INDIANA UNIVERSITY

NORTHWEST CENTER FOR MEDICAL EDUCATION
3400 Broadway
Gary, Indiana 46408
(219) 980-6550

March 6, 1985

We would like to make the following changes in our materials license, number 13-18384-01:

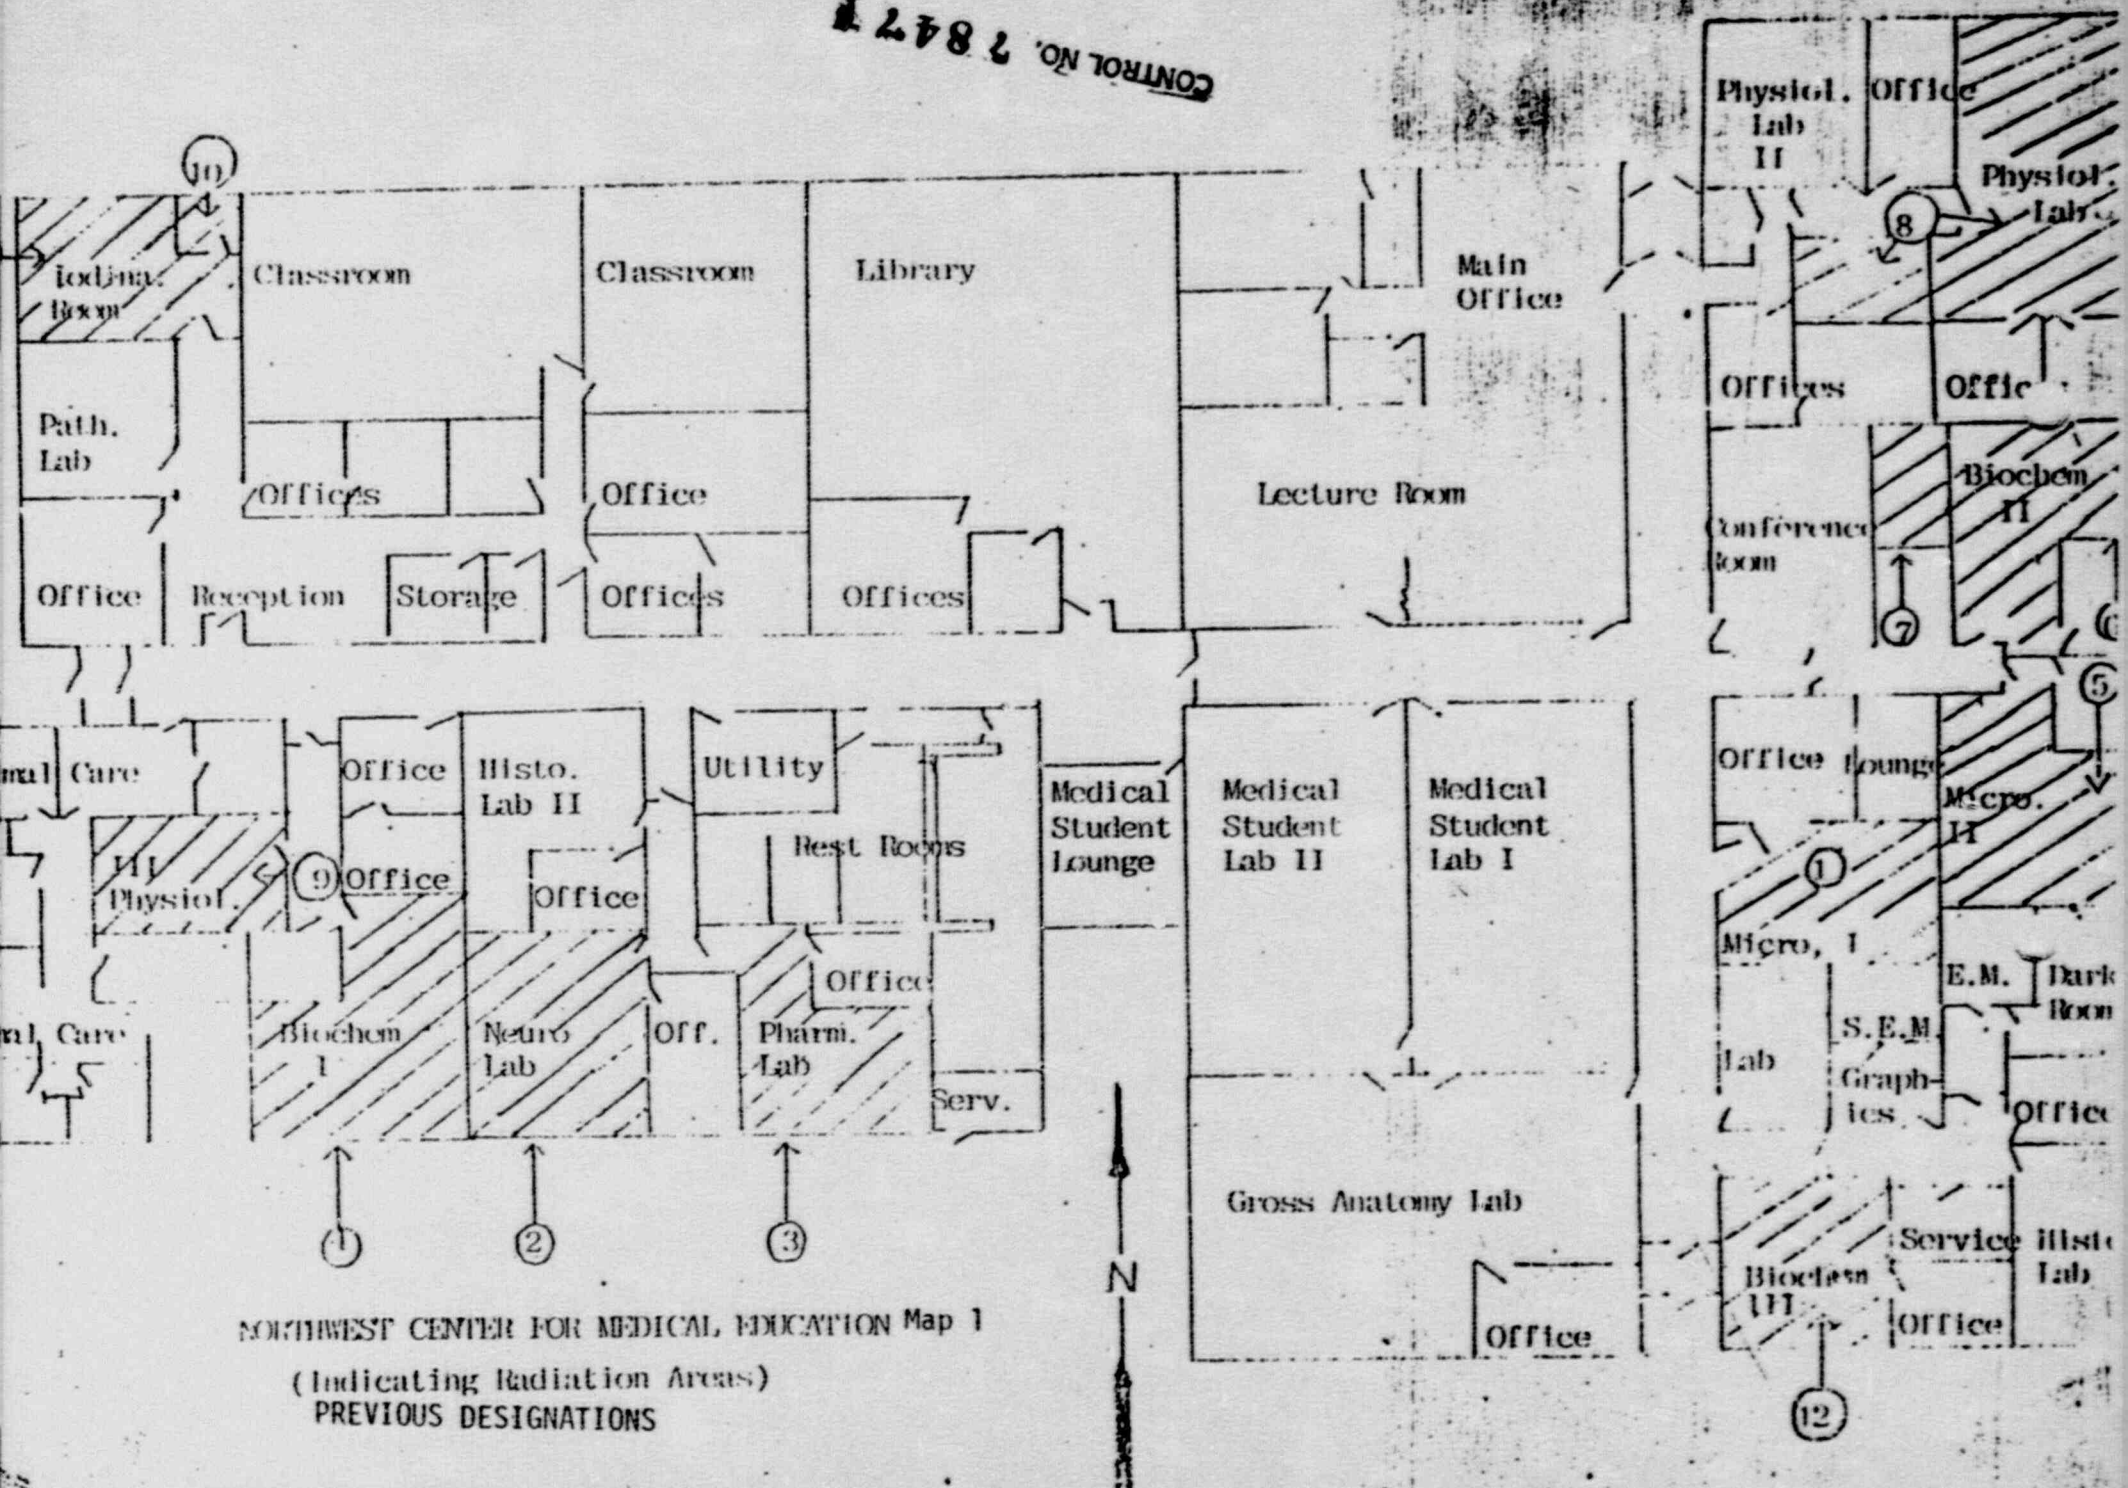
2. We would like to add Dr. Roman Dziarski to our list of responsible investigators. His application and relevant data are enclosed. We would also like to designate his laboratory (formerly Histo II) as a radiation area (now Micro. III Lab-Area 2) (see Northwest Center map 2-new designations and map of this room).

5. Where will radioactive material be used. If appropriate, submit drawing of laboratory, indicating areas of use.

NUCME, Rm 122

NORTHWEST CENTER FOR MEDICAL EDUCATION Map 1
(Indicating Radiation Areas)
PREVIOUS DESIGNATIONS

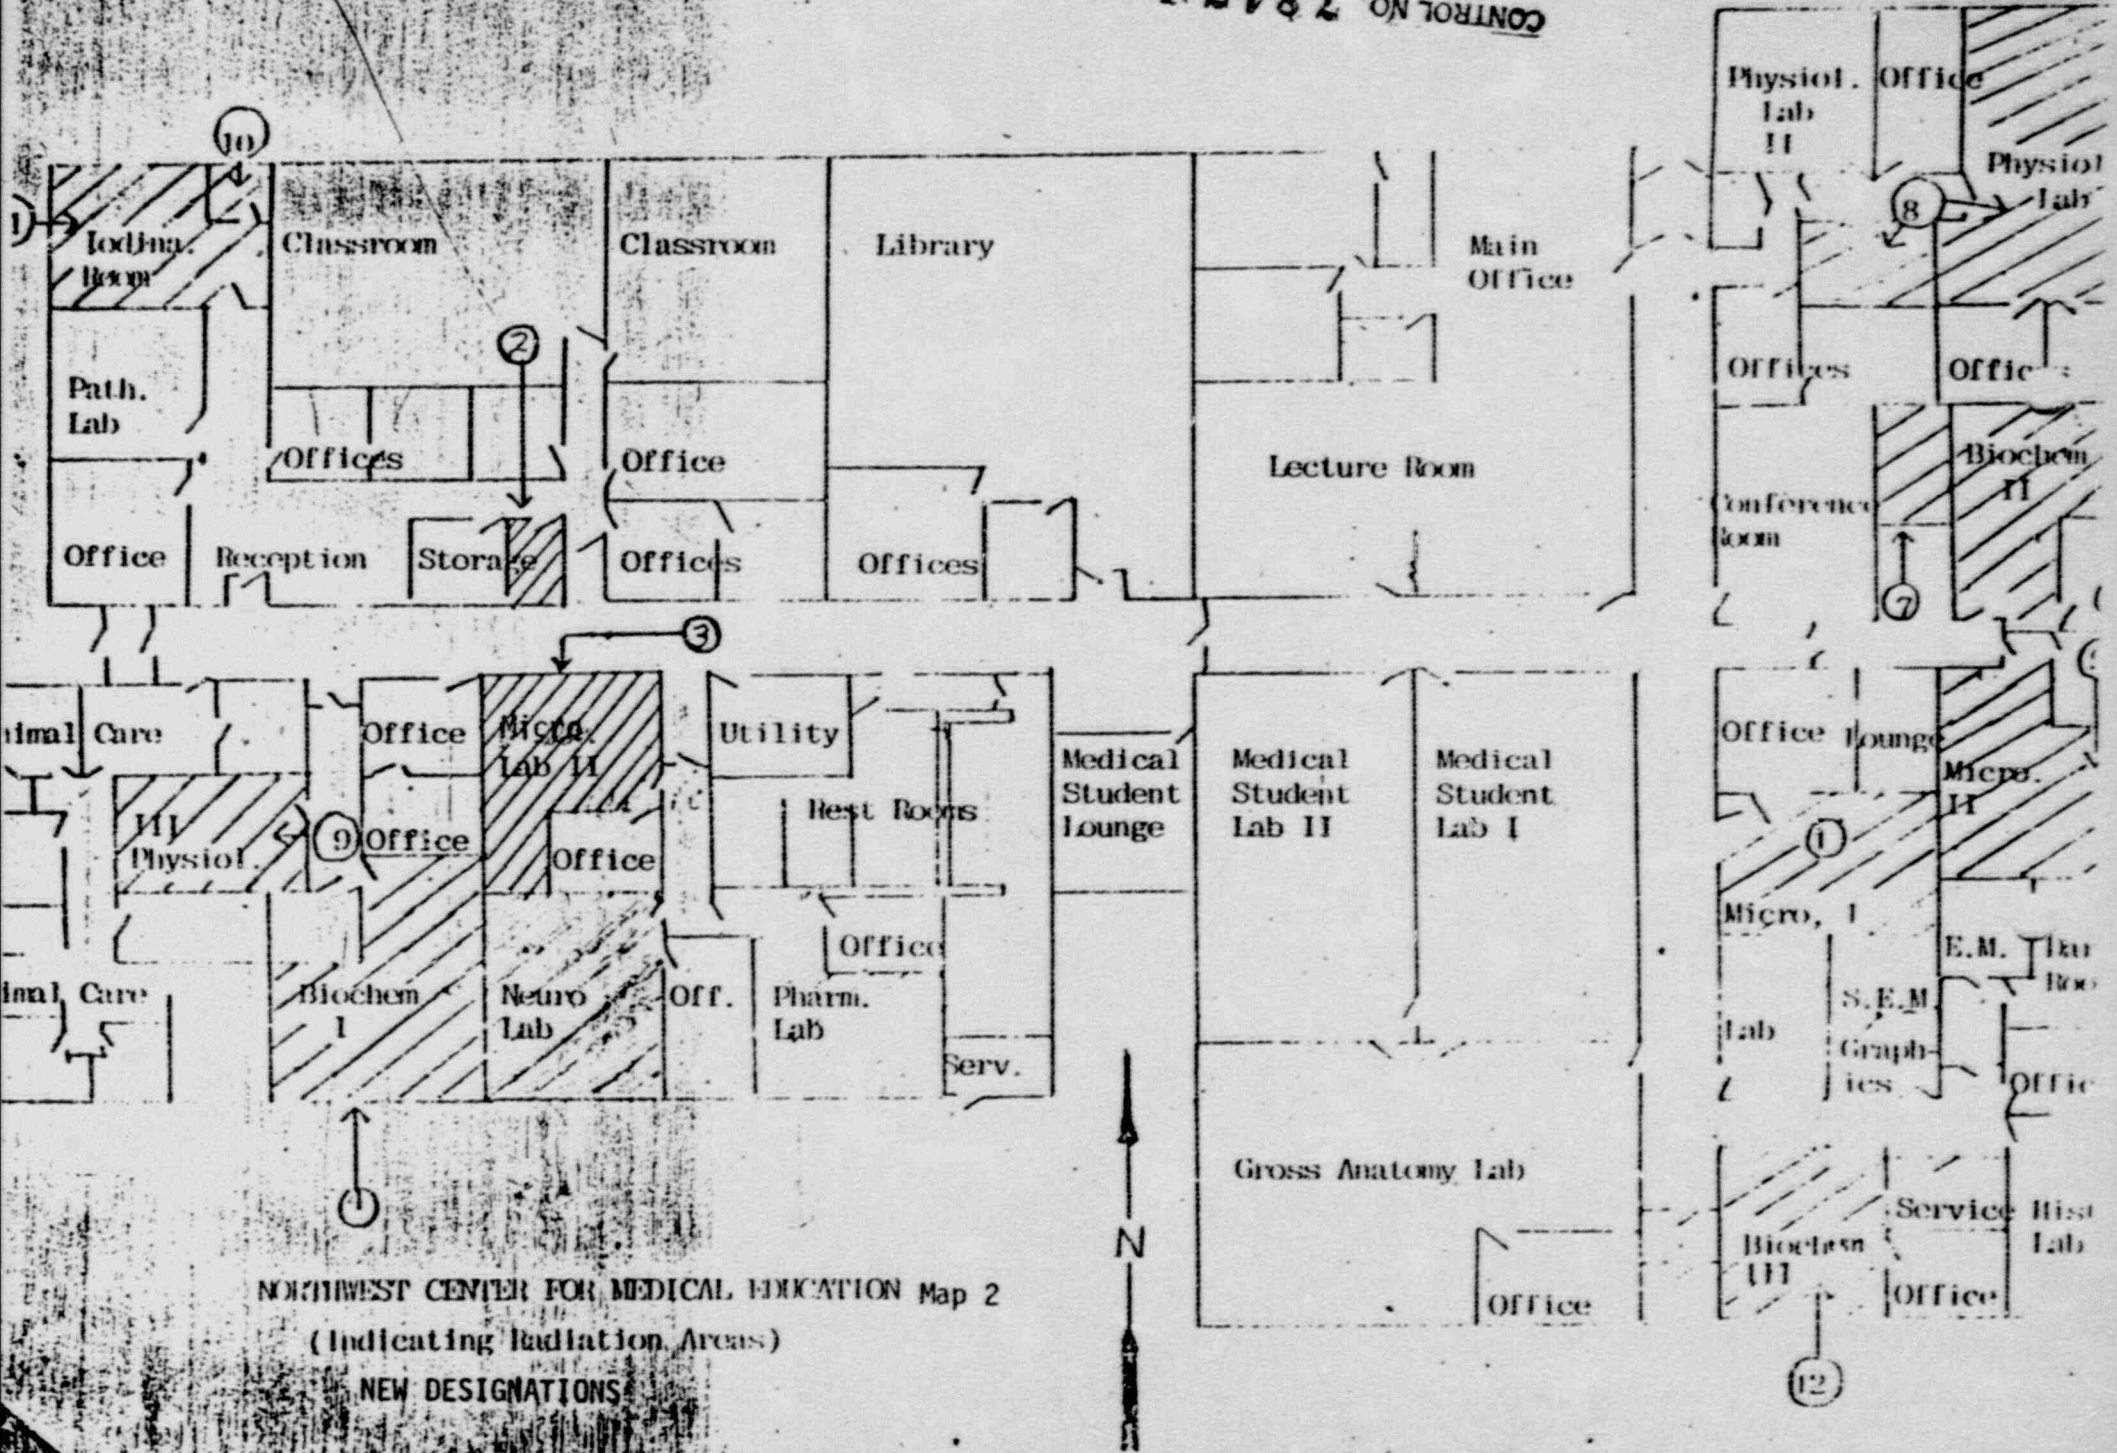
1. We would like to designate Room 112 as a radiation area, designated Area 2 (see Northwest Center map 2-new designations). In this room we would like to locate a liquid scintillation counter and a gamma counter currently located in the Pharm. Lab (see Northwest Center map 1-previous designations Area 3).

4. Due to these changes in our personnel, radiation area 2 and 3 (see Northwest Center map 1-previous designations) are no longer being used for radioisotope work, we would like to delete them from the areas of radiation use and redesignate room 112 as radiation area 3 and the Histo Lab II (now Micro. I Lab) as radiation area 2 (see Northwest Center map 2-new designations).
